# Small-scale DAB coverage change: Stirling & Falkirk

Statement on request to vary the licensed area of the Stirling & Falkirk small-scale radio multiplex

Published 21 February 2025

## Comparison of coverage

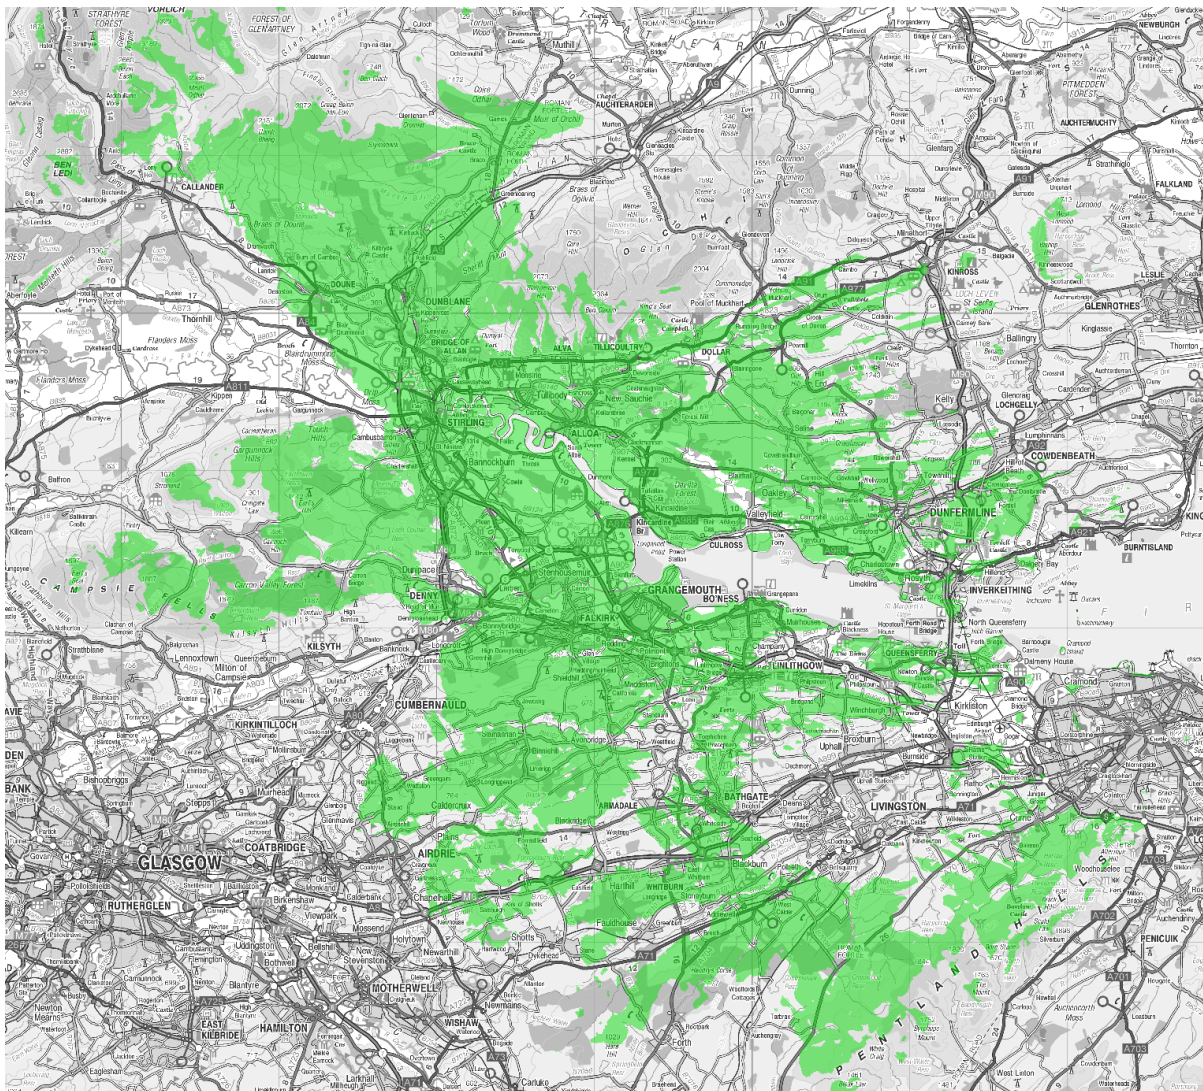
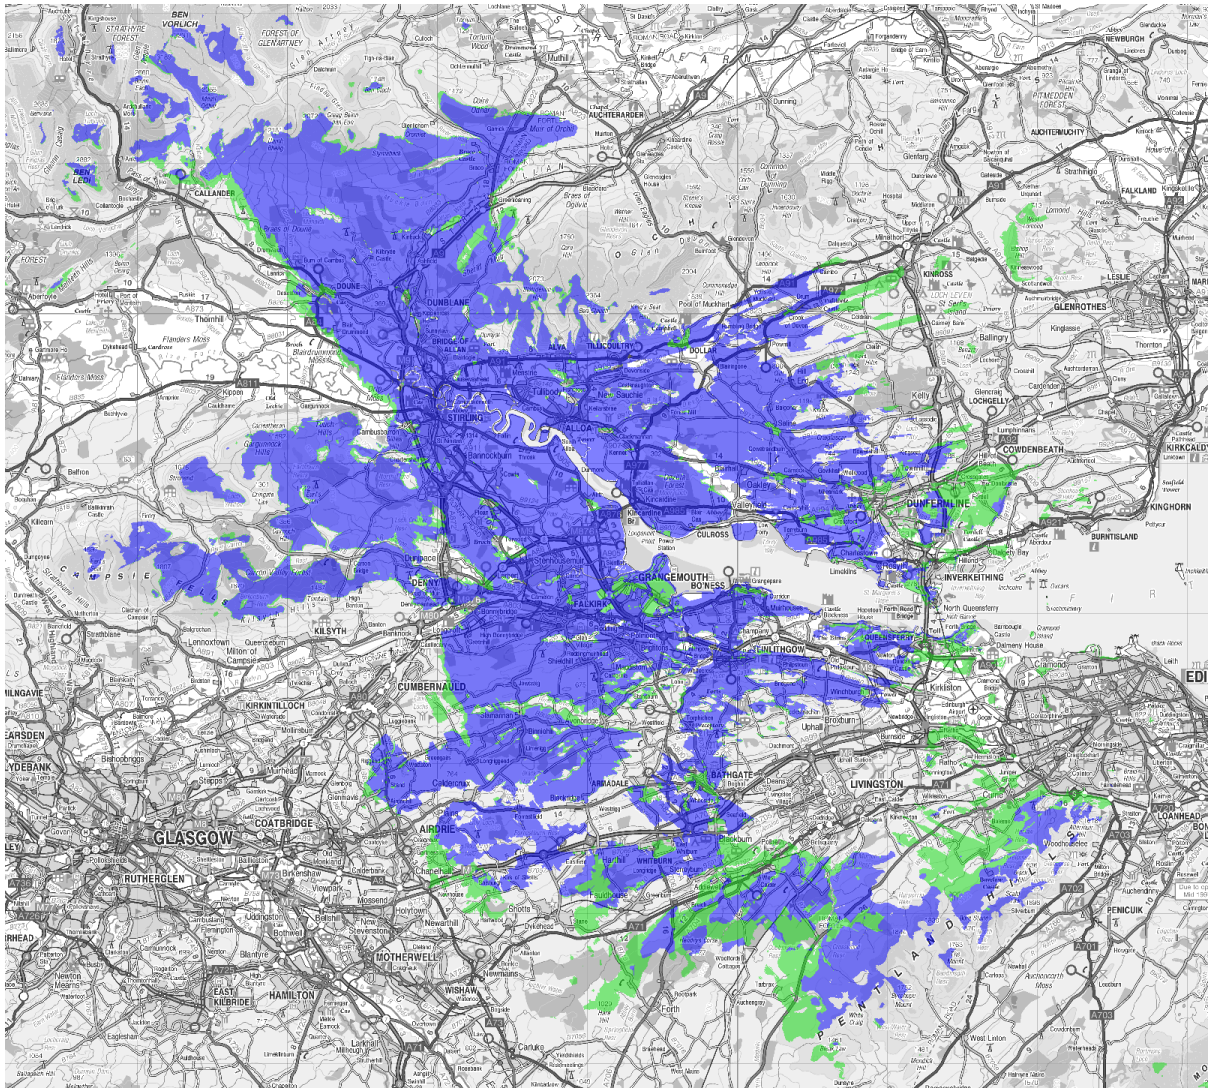
- 3.3 Annex 1 sets out a comparison between the current coverage and that which Ofcom assesses would be achieved by the revised technical plan proposed by the applicant. In brief, the revised technical plan proposes an increase in transmitter power which is predicted to provide a net increase in coverage of around 51,249 adults (aged 15+) compared to the currently licensed coverage area. None of the listeners who are currently served by the multiplex would lose coverage under the revised plan.

- 3.4 The revised technical plan would also result in an area of new coverage outside the existing licensed area, primarily in Dunfermline. Dunfermline is planned to be served by another small-scale radio multiplex service (Dunfermline & Kinross), and was not part of the original Stirling & Falkirk area advertised. The percentage of the population residing in the ‘polygon’ area we plan to advertise in relation to a future Dunfermline & Kinross multiplex that would also be served by the Stirling & Falkirk multiplex would increase from 11.6% to 27.7% - an increase of 16.1 percentage points<sup>2</sup>. We consider this to be material and therefore to constitute an extension to include an adjoining area.

- A1.1 The licensee is proposing a power increase from 260W to 490W for the existing transmitter at Earl’s Hill and from 50W to 140W for the existing transmitter located at Central FM’s studio.
